# DEVELOPMENT REVIEW COMMITTEE (DRC) COMMENT REPORT

**PROJECT NAME:** RK Center Mixed-Use (Parcel I)

**CASE NUMBER:** PLN-SITE-19120001

**REQUEST:** Site Plan Level II Review: 819 Multi-Family Residential Units, 71,960 Square Feet of Retail and Office, 4,000 Square Foot Restaurant, and 4,000 Square Foot Food Hall in Downtown Regional Activity Center

**Existing Stormwater Asset Map possibly affected by the Proposed Development**

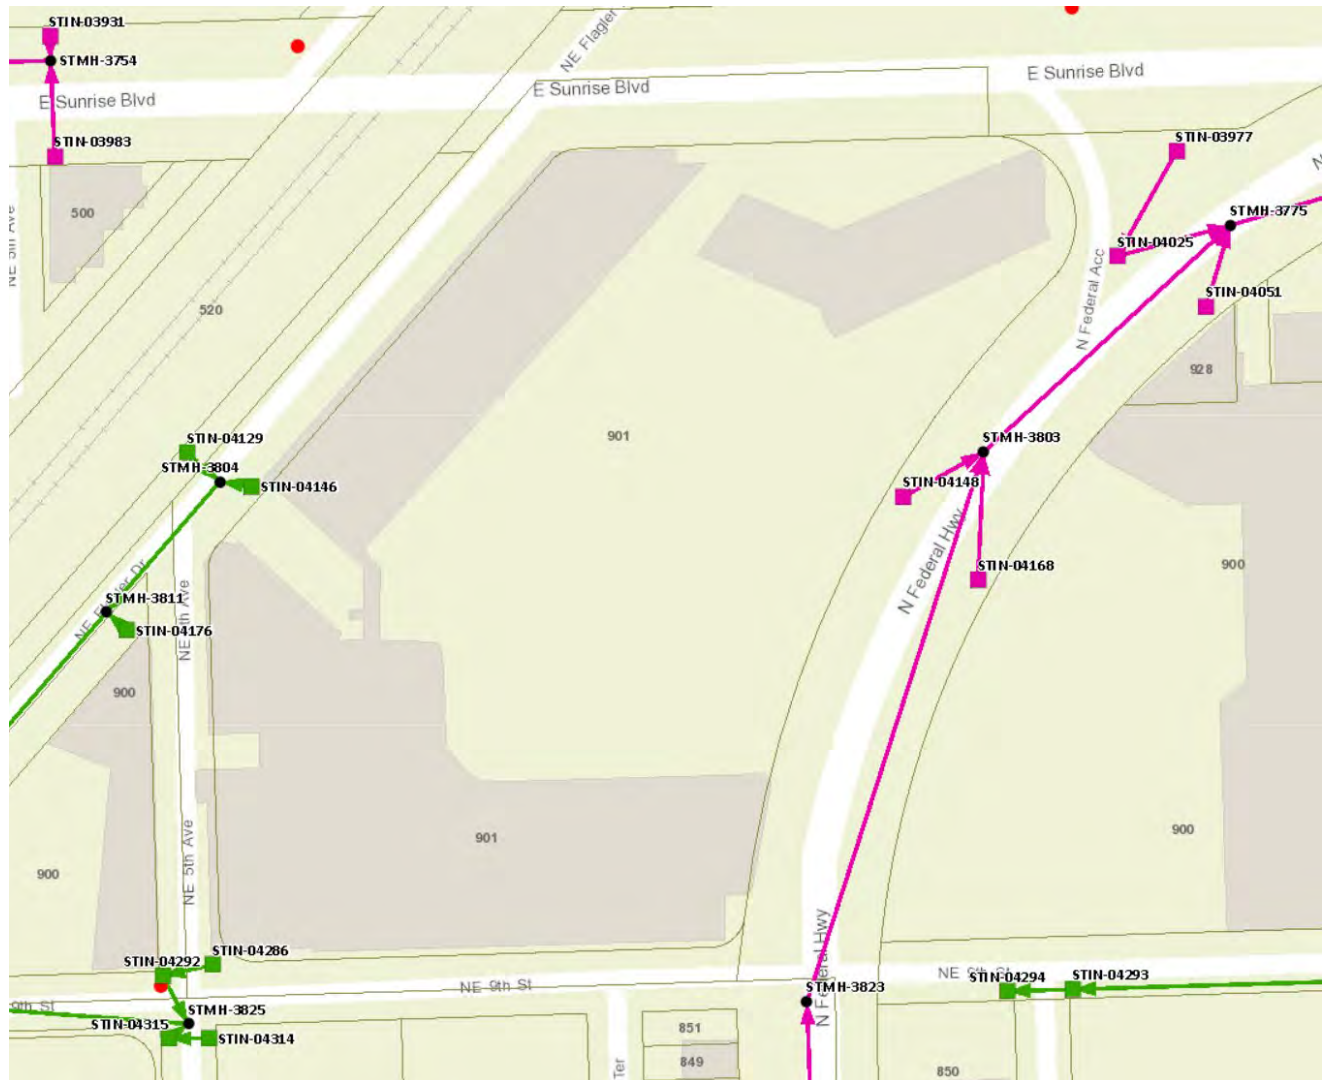
27. Conceptual Paving, Grading, and Drainage:
  - a. Provide sufficient existing and proposed grades and information on conceptual Paving, Grading, and Drainage Plan and details to demonstrate how stormwater runoff will remain onsite (include typical cross-sections along all property lines as appropriate, typical lot grading for the proposed single family homes within the development, and depict how the new stormwater system will connect to the existing on-site drainage system), and how the proposed project improvements (i.e. on-street parking, sidewalks, etc.) will not adversely

impact the adjacent Right-of-Way, properties and waterways. Show location of building roof drains, and their proposed connection(s) to the on-site drainage system. Label existing City storm manholes/inlets using the labels provided in the figure at the end of these notes.
